Item No.: 20B-SIG-01

## NCUTCD Proposal for Changes to the Manual on Uniform Traffic Control Devices

**TECHNICAL COMMITTEE:** Signals Technical Committee  
**ITEM NUMBER:** 20B-SIG-01  
**TOPIC:** Accessible Pedestrian Pushbutton Locations  
**ORIGIN OF REQUEST:** Signals Technical Committee  
**AFFECTED SECTIONS OF MUTCD:** 4I-06 Pedestrian Detectors

**Figure 4I-X. Pushbutton Location Area**

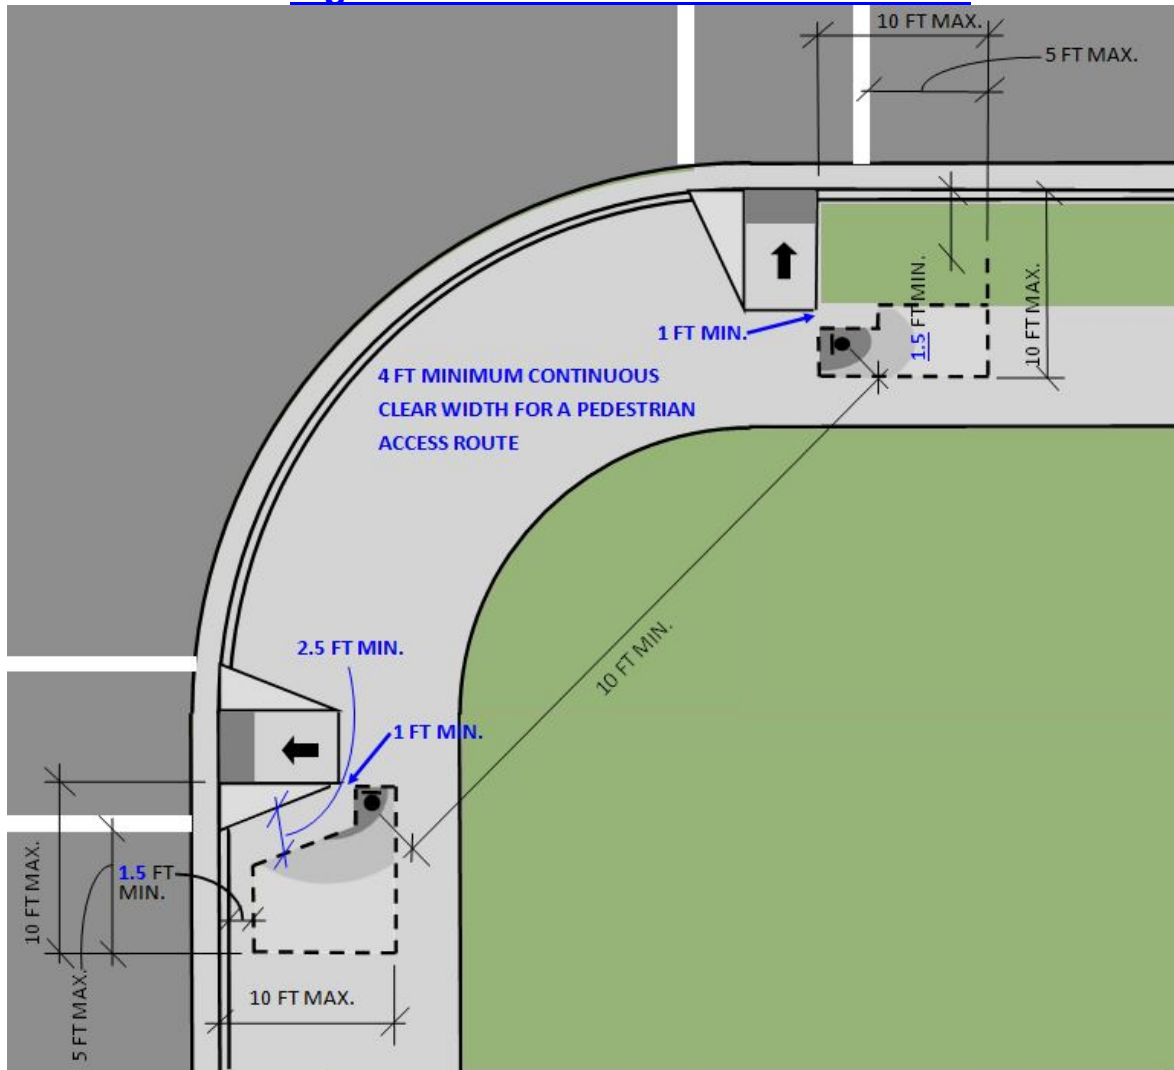
- 47  
48 2. **Revision Figure 4I-X:** When the revisions were approved to Figure 4I-X at the January  
49 2020 National Committee meeting, the minimum distance between the pedestrian  
50 pushbutton and curb was incorrect. The figure showed a minimum distance of 1-foot, yet  
51 the text in Section 4I-06 Guidance clearly indicates the minimum distance is 1.5 feet  
52 which is compliant with the AASHTO clear zone requirements. This proposal changes  
53 the minimum distance from 1 foot to 1.5 feet to be consistent with existing MUTCD  
54 Guidance.

55 **Post Sponsor Comments:** The following revisions have been made to Figure 4I-X: 1)  
56 Note 5 was added to clarify the dimensions in the figure are referenced to the face of the  
57 curb; 2) Dashed lines were included around the “preferred area” in the figure legend; 3)  
58 The shaded areas designating permissible pushbutton location were pulled back 2.5 feet  
59 from the ramp flares and 1 foot from the top of the ramp to be in compliance with  
60 PROWAG; 4) The phrase “center of the intersection” was added to Note 1 to be  
61 consistent with Figure 4I-Y.

**Figure 4I-XY. Pushbutton Location Area For Use Where A Single Ramp Exists Or Is The Only Available Alternative**

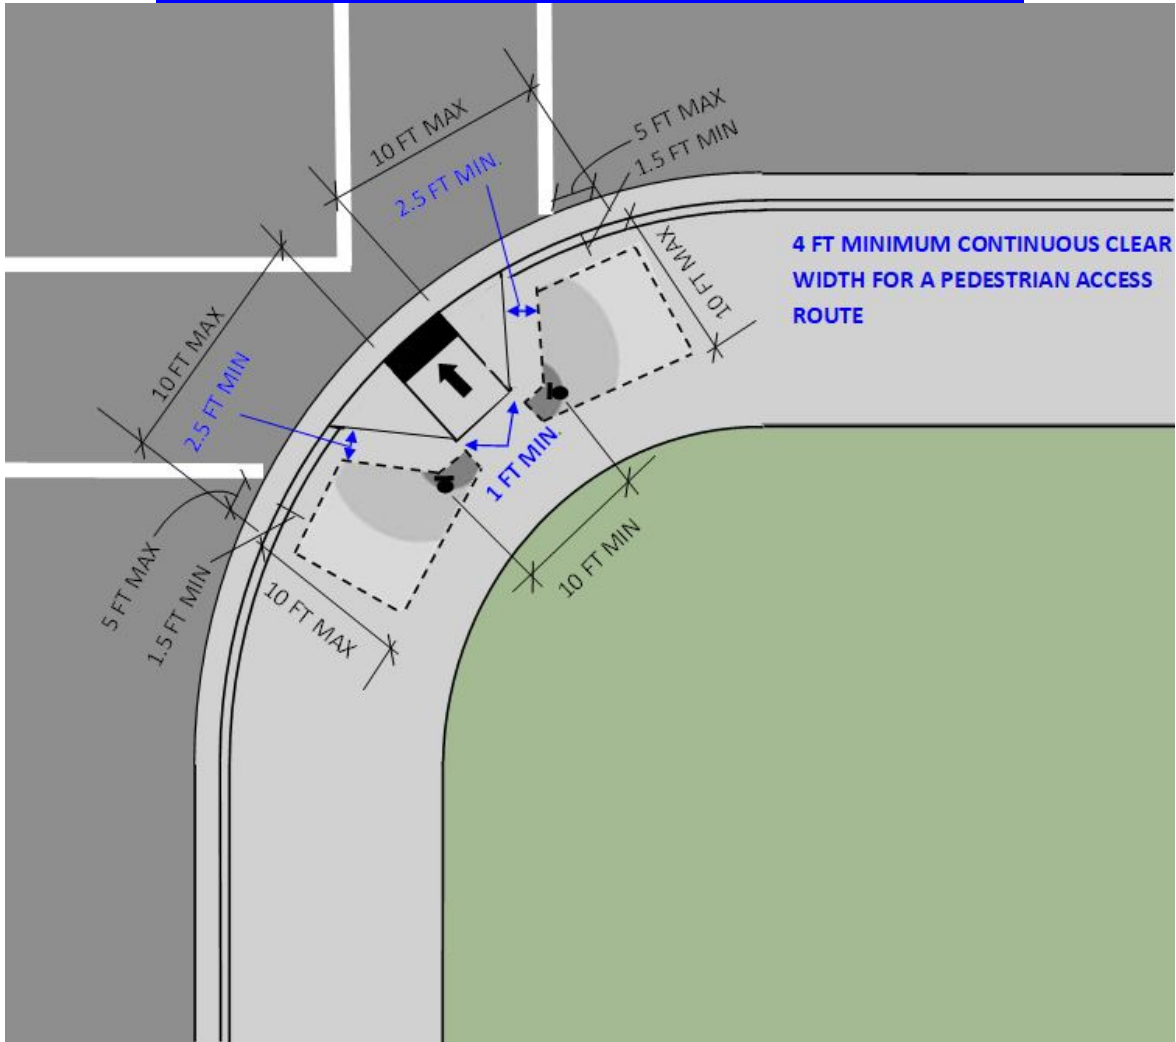
1. **Proposed Figure 4I-Y:** Very little guidance is provided for the placement of pedestrian detectors on street corners with a single pedestrian access ramp serving two crosswalks. The practice of using a single ramp to serve two crosswalks is not recommended because of the added complexities for pedestrians with disabilities. However, physical constraints frequently limit a corner to a single ramp. Positioning pedestrian detectors on corners with single access ramps is more challenging than on corners with two ramps because single ramp corners do not allow optimum placement to accommodate all types of disabilities. The needs of vision impaired pedestrians are different than those of mobility impaired pedestrians. The goal is to develop a design that, although not optimum, will

35 work for all disabilities. A revised figure is proposed which would clarify proper  
36 placement of pedestrian detectors while allowing for defined flexibility and latitude,  
37 where necessary, to accommodate unique conditions for a given location. These  
38 revisions are shown in a new Figure 4I-Y.

39 **Post Sponsor Comments:** The following revisions have been made to Figure 4I-Y: 1)  
40 The notes were revised to be consistent with the notes on Figure 4I-X; 2) The shaded  
41 areas designating permissible pushbutton location were pulled back 2.5 feet from the  
42 ramp flares and 1 foot from the top of the ramp to be in compliance with PROWAG; 3)  
43 The figure number in the heading was changed from 4I-X to 4I-Y; 4) The “preferred  
44 area” shading was changed from liner to radial; 5) Dashed lines were included around the  
45 “preferred area” in the legend; 6) The figure reference in Note 7 was corrected to reflect  
46 the correct figure number
